ADMINISTRATIVE AMENDMENT NOTICE

Petitioner #: 2008-027

Acreage & Location: Approximately 6.05 acres located on the north side of Ballantyne

THE VILLAS AT ALEXANDER PLACE

SITE PLAN SCALE: 1" = 40'

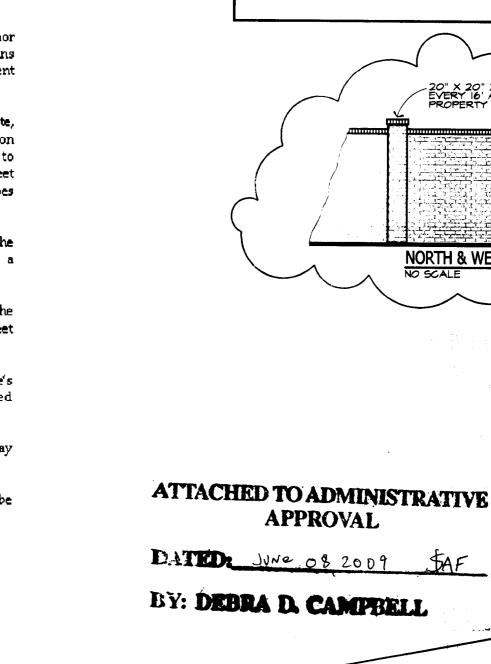
The amendment makes a minor change to the approved Rezoning Petition to modify the approved townhomes to allow the development of duplexes while maintaining the approved 27 units, in accordance with Section 6.207 of the City of Charlotte Zoning Ordinance. Adjacent property owners may appeal the approval of the administrative amendment to the Zoning Committee of the Planning Commission twenty-one days from the date of this notice.
